Document Information			
Document #	0201741/02-RCA-0272	**Revision**	
Title	QUARTERLY NOTIFICATION OF CLASS 1 MODIFICATIONS TO THE HANFORD FACILITY RESOURCE CONSERVATION AND RECOVERY ACT (RCRA) PERMIT, DANGEROUS WASTE PORTION (QUARTER ENDING MARCH 31, 2002 - PERMIT CONDITION I.C.3)		
Date	04/09/2002		
Originator	J. HEBDON, R. H. GURSKE, R. D.(ROBY) ENGE	**Originator Co.**	DOE, FH, PNNL
Recipient	L. E. RUUD	**Recipient Co.**	DOEC
References			
Keywords			
Projects			
Other Information

APPENDIX 4B

DETAILED DRAWINGS FOR THE 200 AREA EFFLUENT TREATMENT FACILITY CONTAINER STORAGE AREA AND TANK SYSTEMS

ENGINEERING CHANGE NOTICE

ECN No	Page
662006	11 OF 54
Ref Dwg	Sh / Rev
H-2-88980	1 / 10
Zone	
AS SHOWN

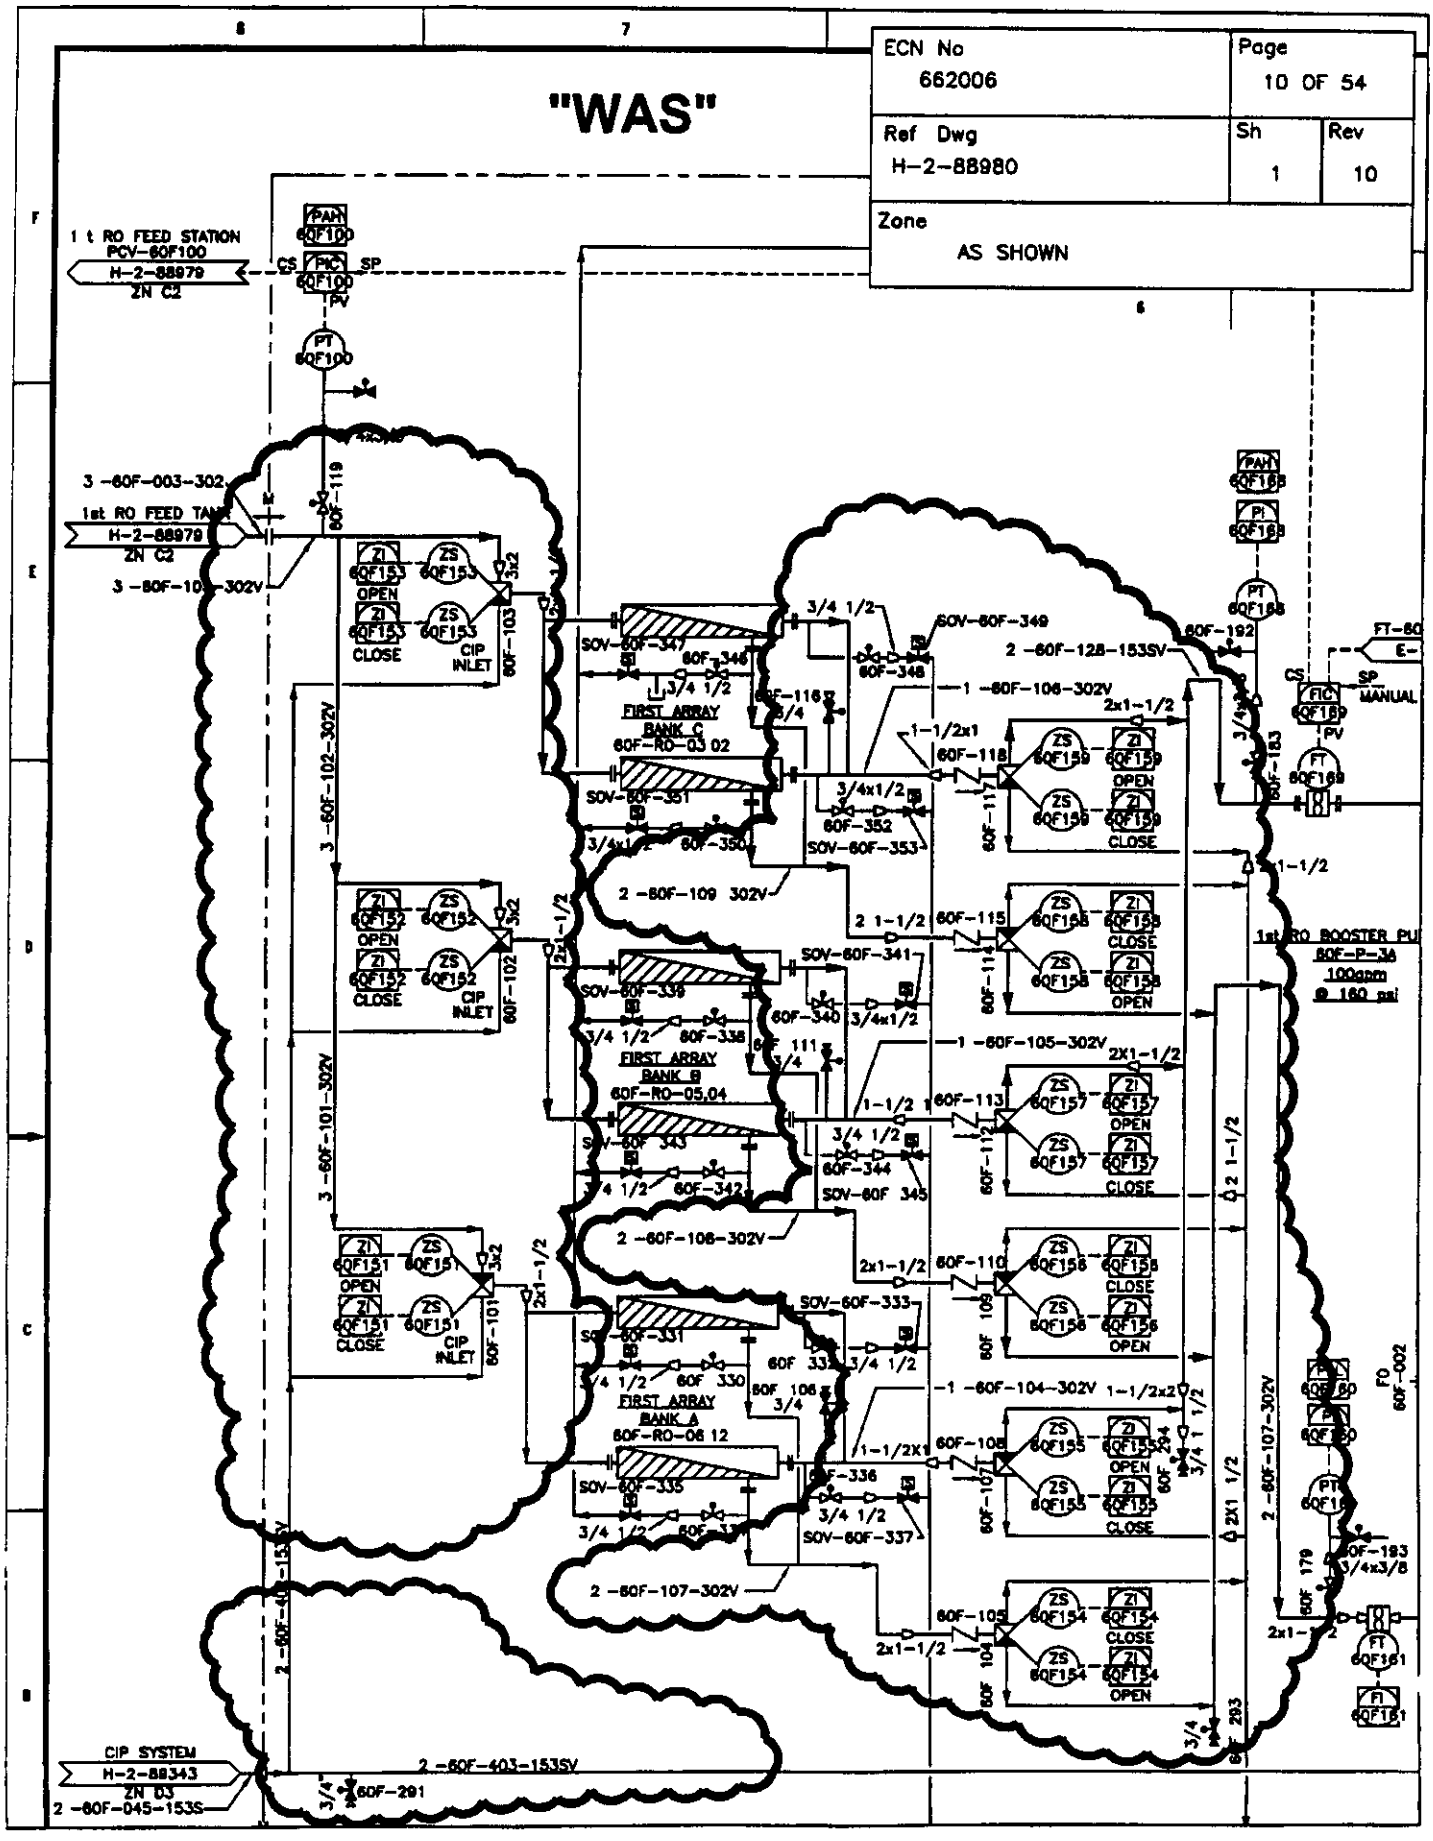
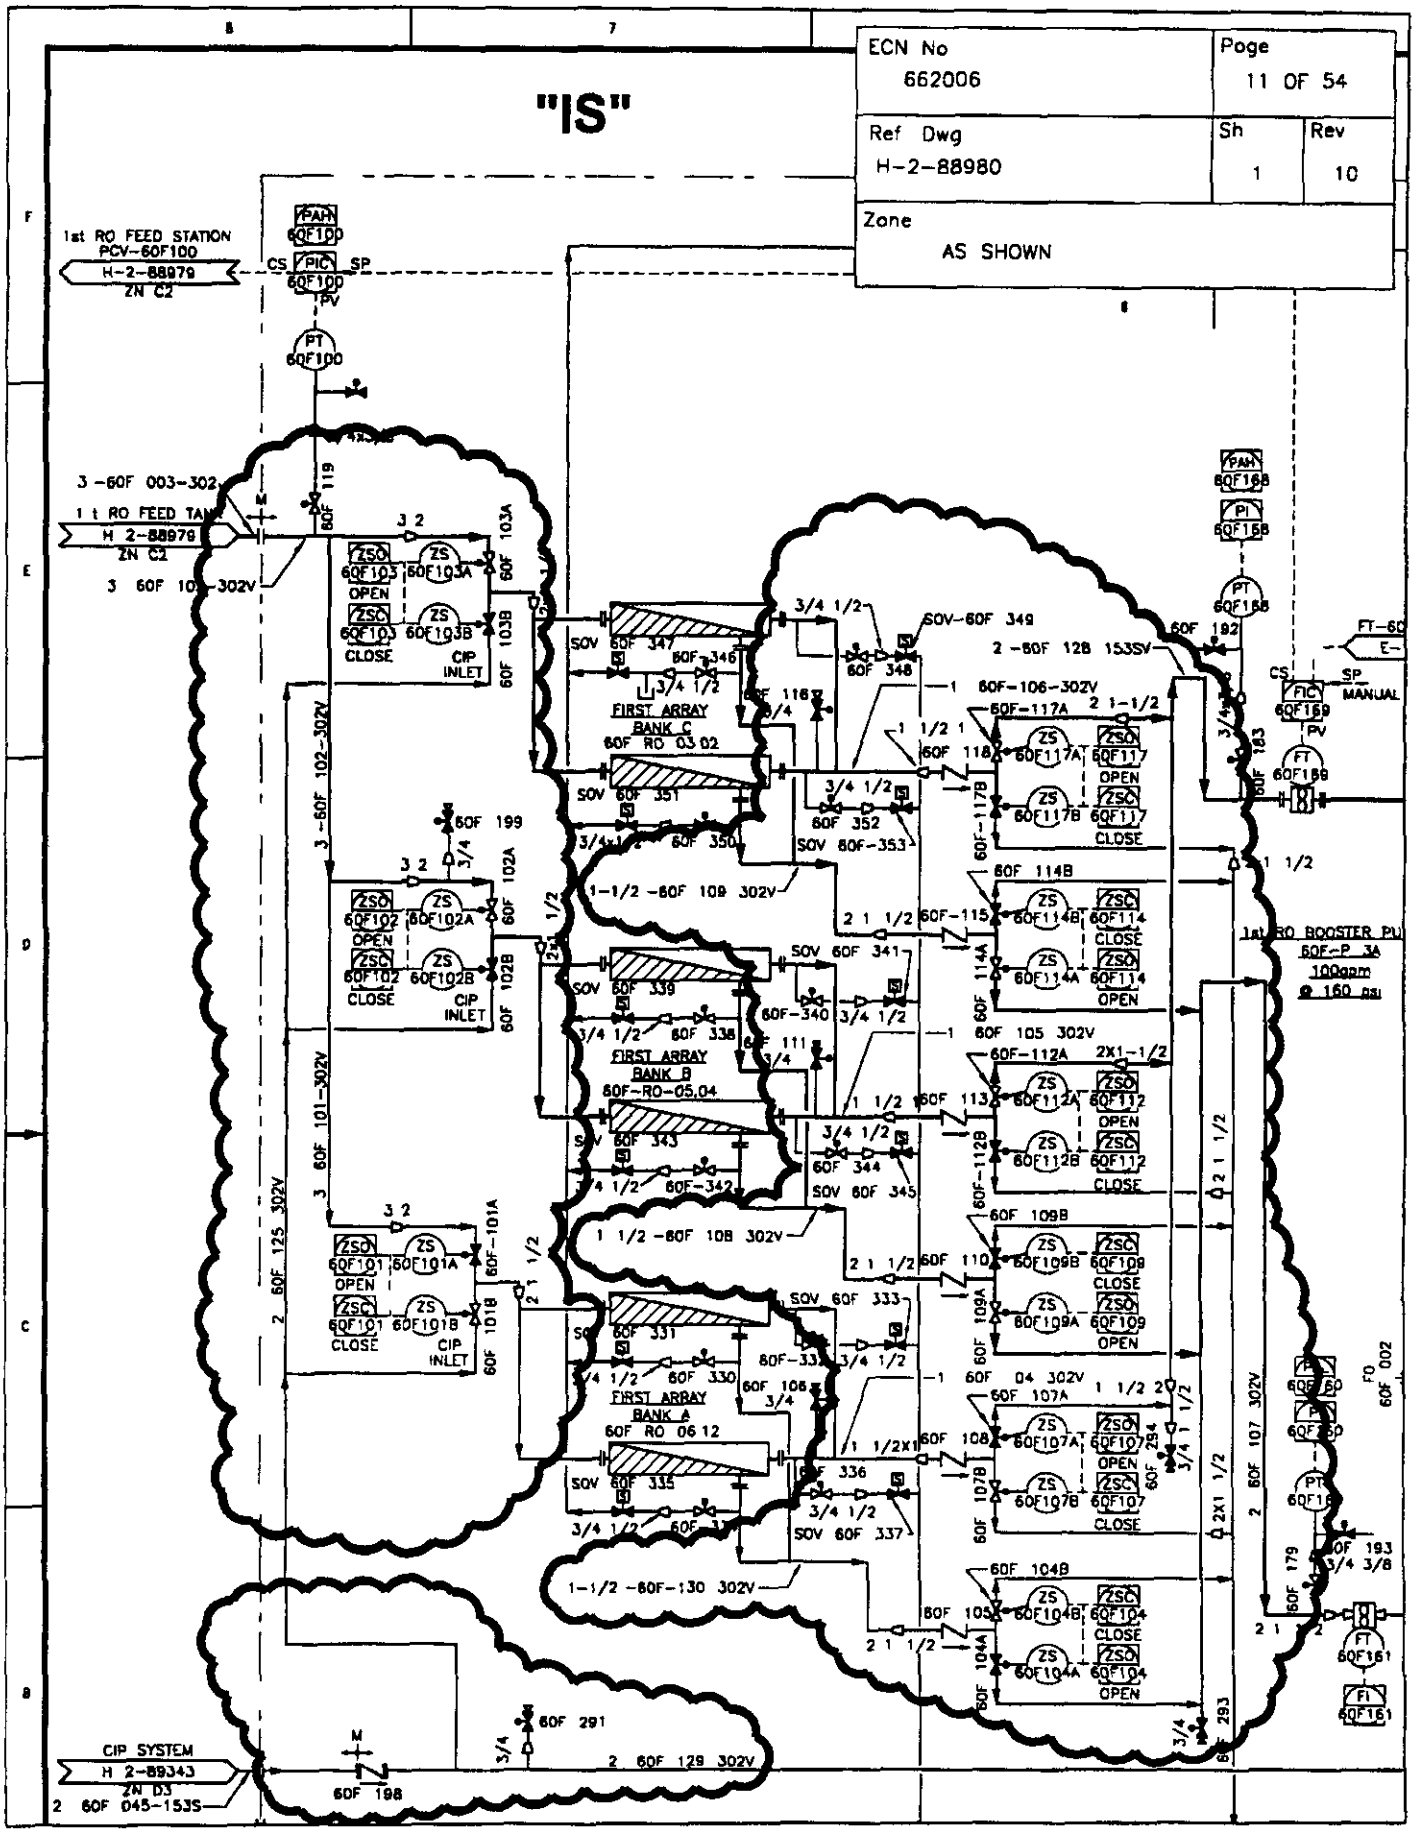
Remove and replace 3-Way ball valve 60F-103 with two 2-Way ball valves Label new valve downsteam of pipeline 3 -60F-103-302V with valve number 60F-103A Label other new 2-way valve 60F-103B

Remove and replace 3-Way ball valve 60F-102 with two 2-Way ball valves Label new valve downsteam of pipeline 3 -60F-102-302V with valve number 60F-102A Label other new 2-way valve 60F-102B

Remove and replace 3-Way ball valve 60F-101 with two 2-Way ball valves Label new valve downsteam of pipeline 3 -60F-101-302V with valve number 60F-101A Label other new 2-way valve 60F-101B

Ref Dwg	Sh	Rev
H-2-88980	1	10

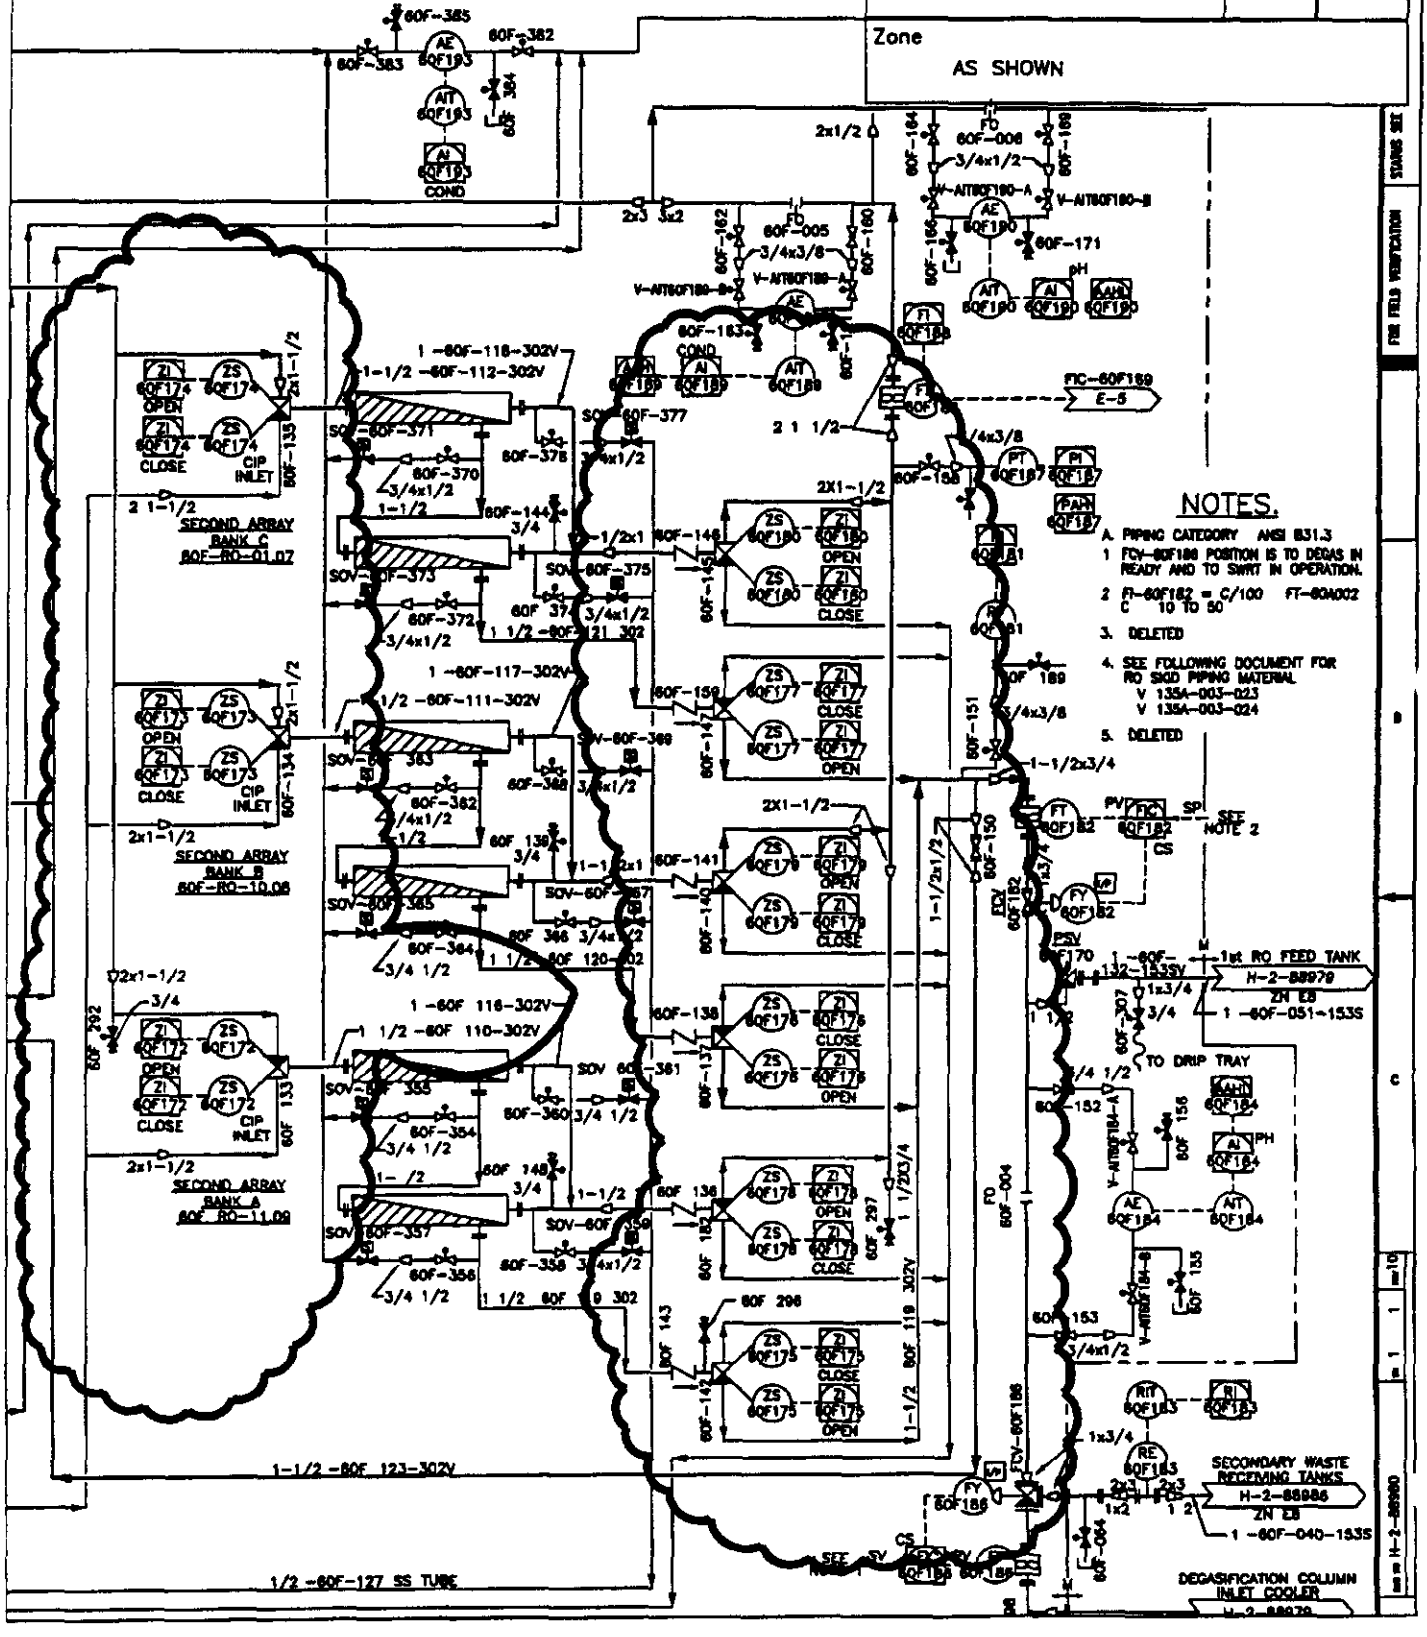
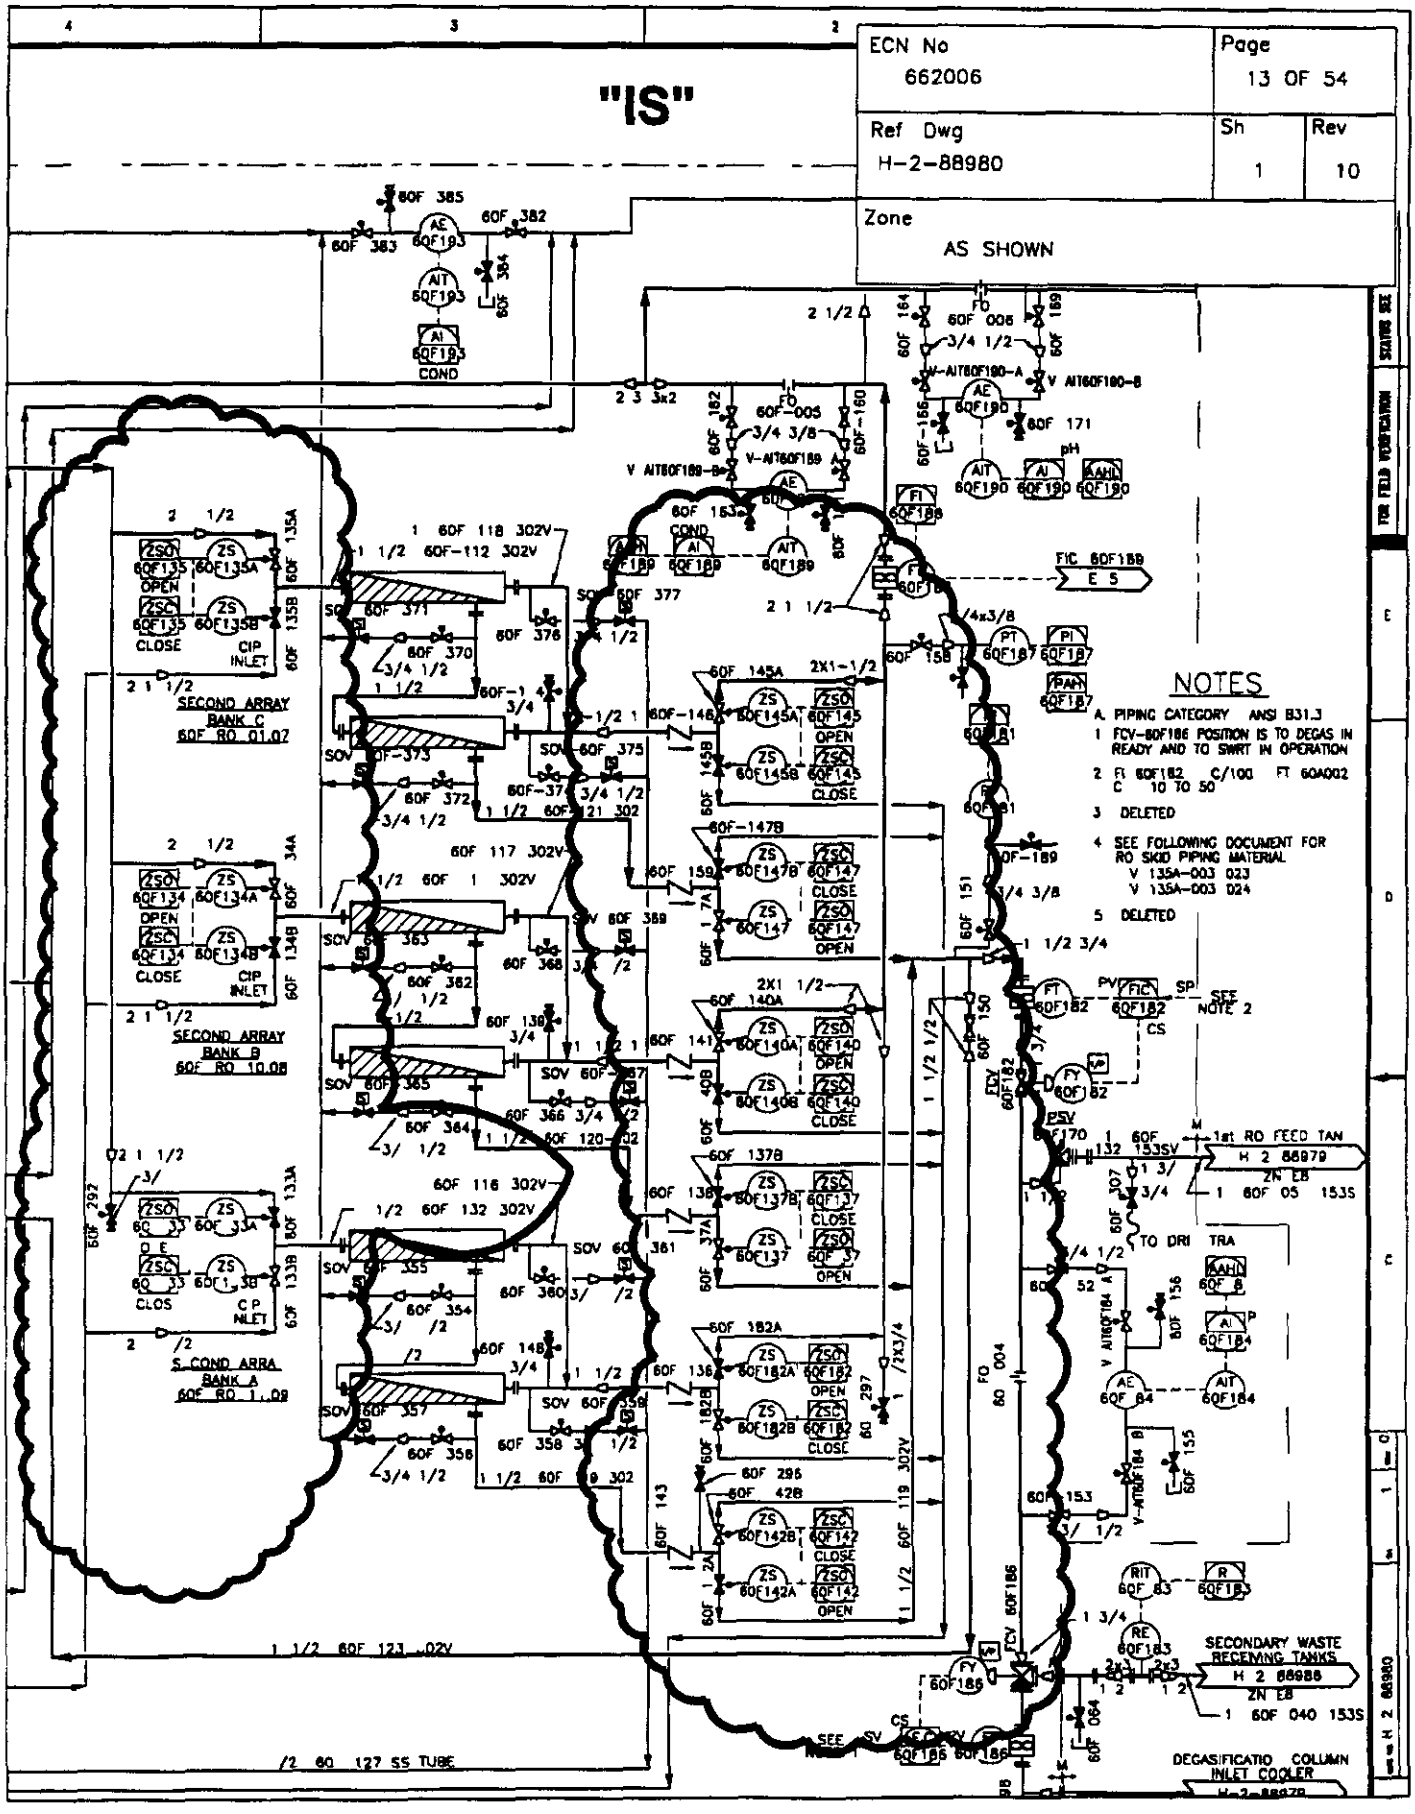
Remove and replace 3-Way ball valve 60F-117 with two 2-Way ball valves Label new valve upstream of pipeline 2 -60F-128-153SV with valve number 60F-117A Label other new 2-way valve 60F-117B

Remove and replace 3-Way ball valve 60F-114 with two 2-Way ball valves Label new valve upstream of pipeline 2 -60F-107-302V with valve number 60F-114A Label other new 2-way valve 60F-114B
